Before a hearing held by Environment Southland

An application by Meridian Energy to
excavate a channel in the bed of the
Waiau Arm of Lake Manapouri/Lower
Waiau River. Application AP
20233670.

Statement of Evidence of the Waiau Working Party.

Figure 5. Image showing the diversion channel and distributary fan of the Mararoa River where at least four channels were present with two large islands now overgrown with grasses and willows. Approximate area of land (>180.5masl) on the right bank of the proposed new channel is shown in blue.

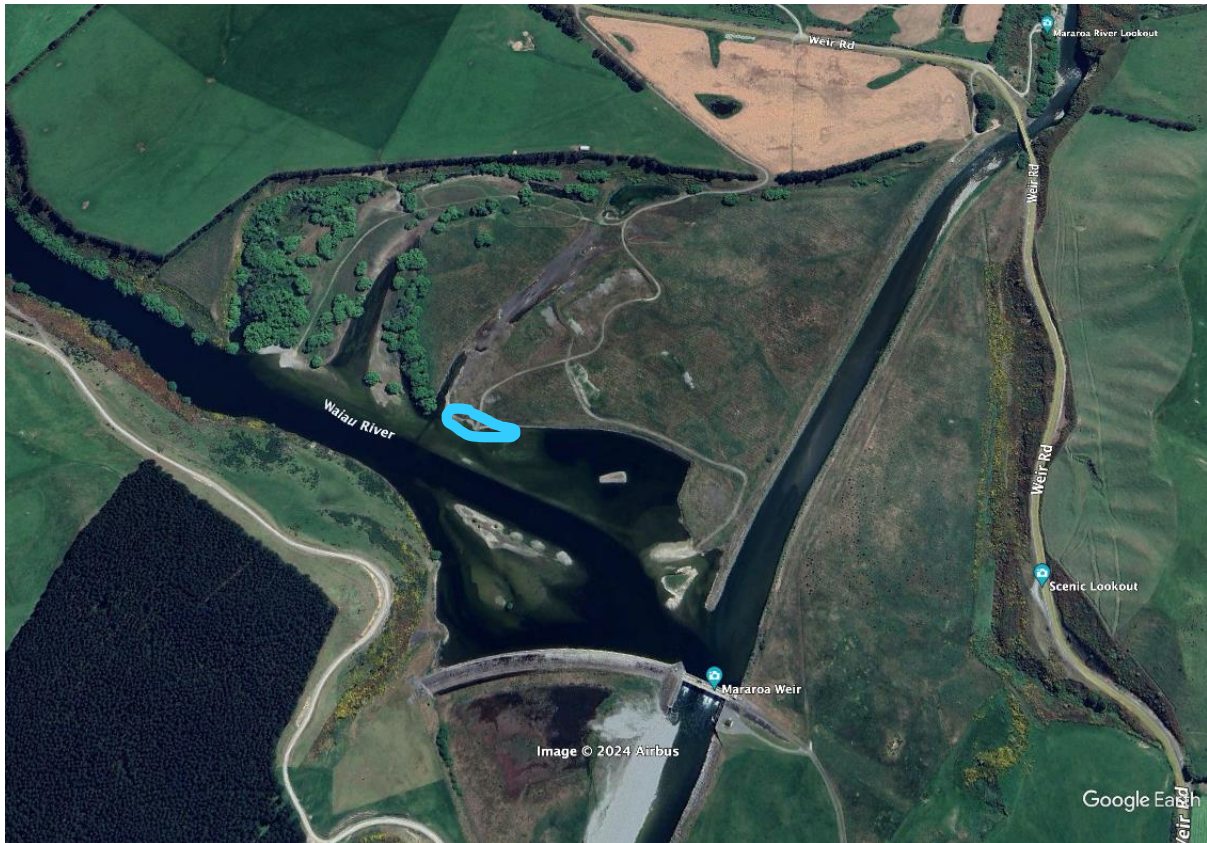
have been suitable for nesting of BBG and other river birds such as banded dotterels and oystercatchers. The Mararoa fan is now unsuitable for BBG nesting as it has become overgrown with long grasses and woody vegetation including crack willow trees. There are no gravel islands present now. Figure 5. (Google Earth image 2023)

41. As can be seen in Figure 5 above the old Mararoa River delta had 4 distributary channels. These are now wetlands that have a variable amount of water in them

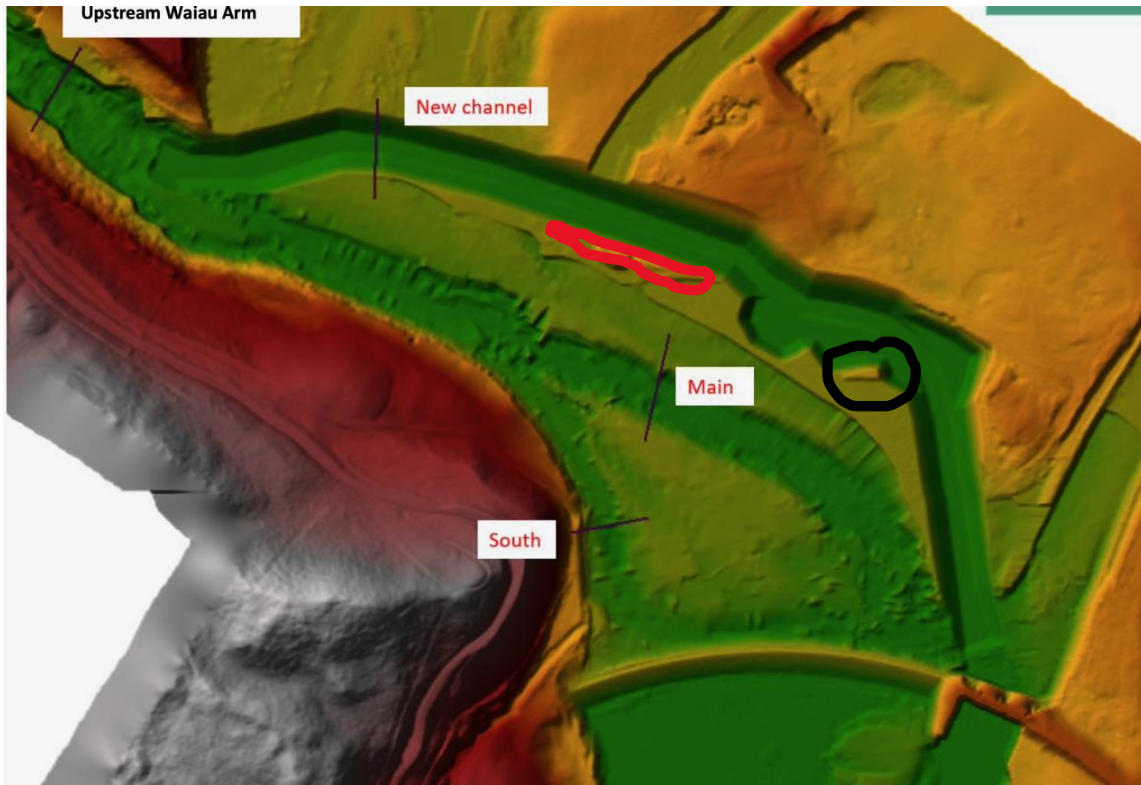
38. We believe that the construction of a suitable island could be integrated into the works needed to construct the channel. At low lake levels the area where the new

39. Another image of the proposed island, along with the existing island is shown generally below (Fig 7) (Image provided by Meridian in papers presented for the consent application).

An additional condition is required to provide for nesting habitat for river birds. After the existing sentence add: An area of excavated material (gravel, sand and boulders) of no less than 2500m² that is above 180.5 metres above sea level and contoured to the surrounding landscape is provided on the right bank of the new channel to form an

island. The consent holder shall maintain the island free of all live vegetation (trees, shrubs and grasses), and when black billed gulls are nesting there prepare and implement a predator control programme to the satisfaction of the consent authority.
